7901 2nd Ave S, LLC
P. O. Box 80464
Seattle, WA 98108

October 21, 2025

Re: 7901 2nd Avenue S. LLC – Comments on Proposed Agreed Order, Cleanup Action Plan,
and SEPA Determinations for 7901 2nd Ave S LLC and for Kenyon Industrial Park

7901 2nd AVENUE S.
PROPERTY AND
BORING LOCATIONS

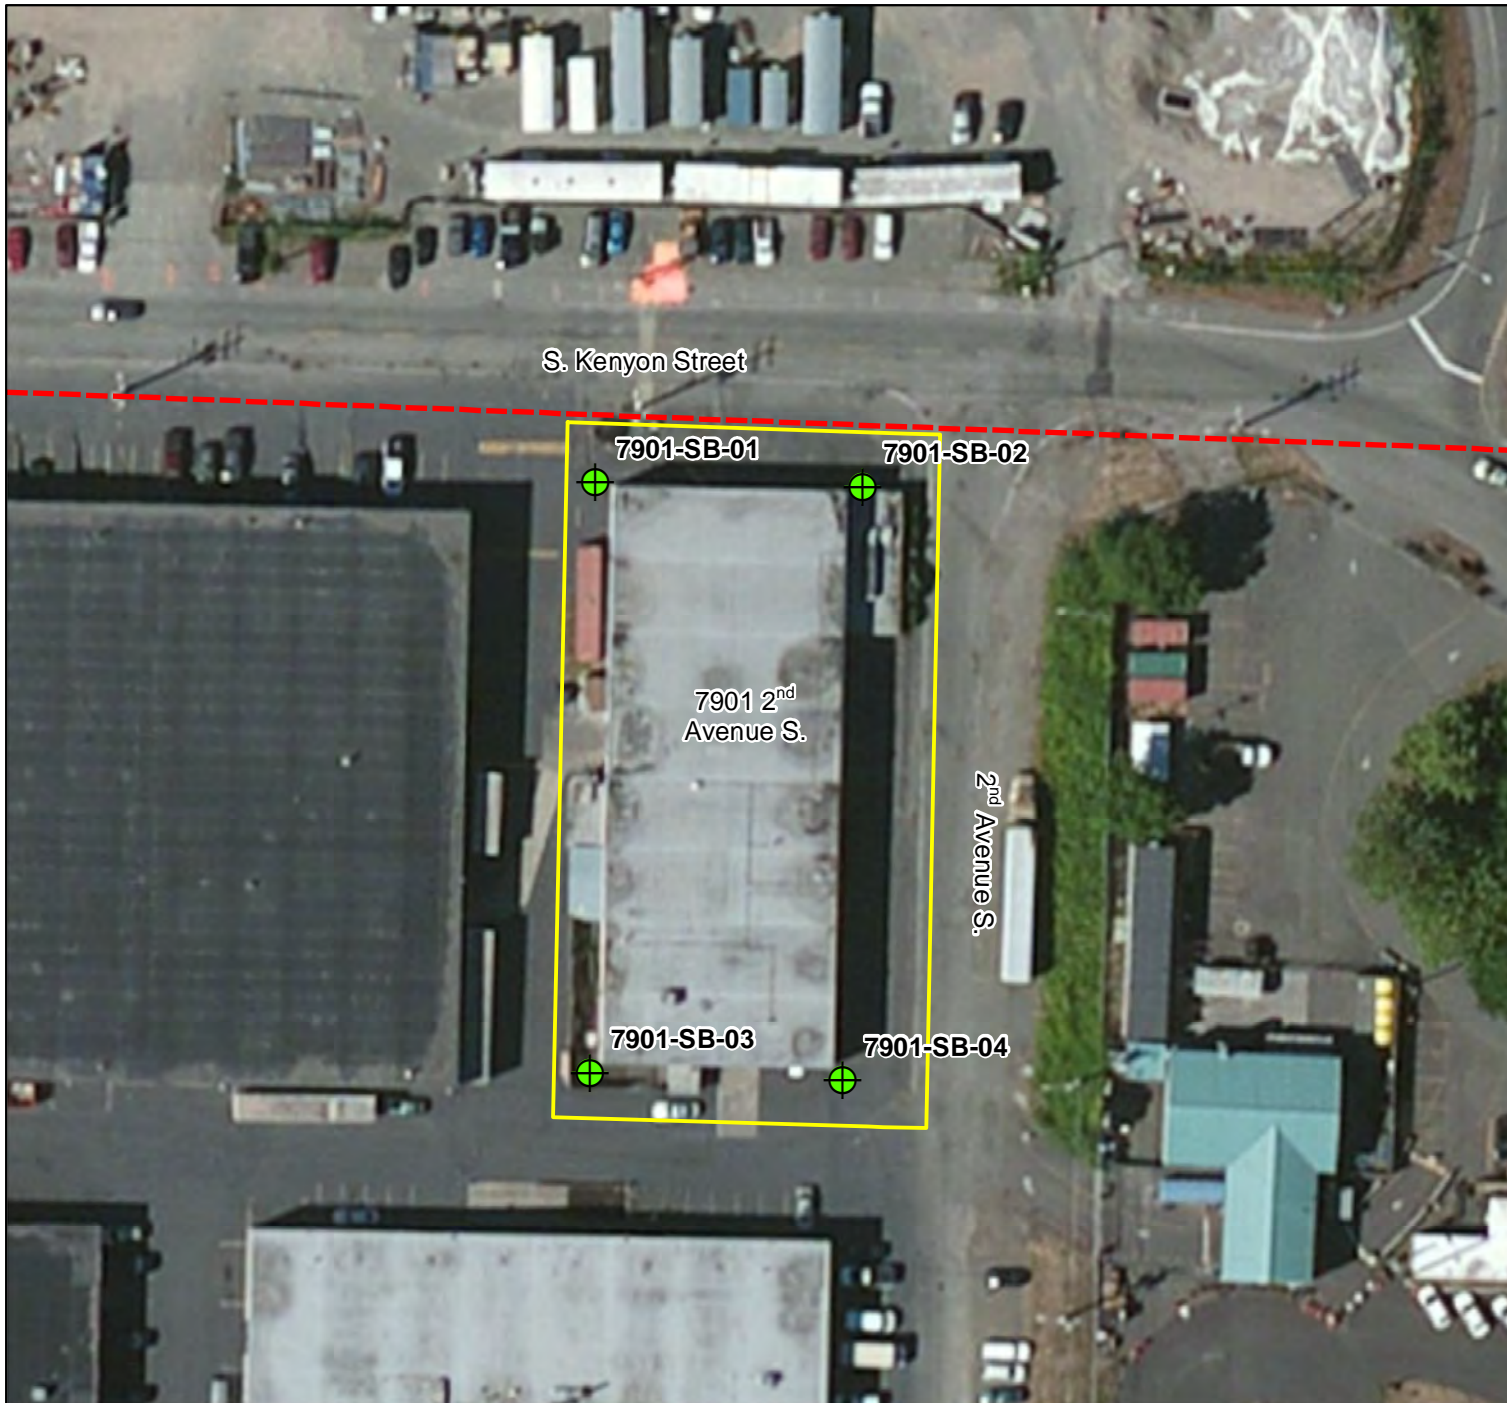
Ecology is electing to do so, however, without an adequate factual basis and where there is no factual evidence of historical municipal solid waste ("MSW") disposal on the 7901 property. The only "solid waste or impacted waste" found in borings drilled in May 2017, which were drilled at each of the four corners of the 7901 property through the existing pavement, was demolition debris in the form of nails and bricks in Boring 2 and "some wood chips" in Boring 1. There was no MSW detected in any of the borings, each of which was drilled to a maximum depth of 20 feet below ground surface ("bgs").

Ecology is requiring a minimum thickness of 12 inches of fill material over "the solid waste or impacted waste". The demolition debris in Boring 2 was detected at 2.5-3 feet bgs (nails) and at 4.5-5 feet bgs (bricks). The wood chips in Boring 1 were detected at 9.3-10 feet bgs. The shallowest impacts – in the form of "weak petroleum odor" – were detected at depths below 9 feet bgs in Boring 1 and 14.5-15 feet bgs in Boring 2. Although "garbage-like odor" was detected at 4.6-4.9 feet bgs in Boring 3 and 3.5-4 feet in Boring 4, neither boring detected any MSW. A copy of the borings and the site figure showing the locations of the borings are attached.

Therefore, the 7901 property already meets the minimum thickness requirement of 12 inches of fill material over any alleged "solid waste or impacted waste". Despite this, to the detriment of the community in the form of substantial truck traffic to haul out asphalt and haul in new pavement materials to the 7901 property and the Kenyon Industrial Park property, Ecology is requiring that the existing pavement be torn out and replaced with either a 3-inch minimum thickness for asphaltic concrete or a 4-inch minimum thickness for cement concrete to cover an already over-10-foot thick layer of fill material. There is no factual basis upon which to require a *de minimis* party such as 7901 to incur the thousands of costs – including the associated disruptions to its tenants' businesses and the enormous truck traffic and noise that the removal and replacement of the pavement will cause – to rip out pavement that is already maintained and in good condition, absent any evidence whatsoever that
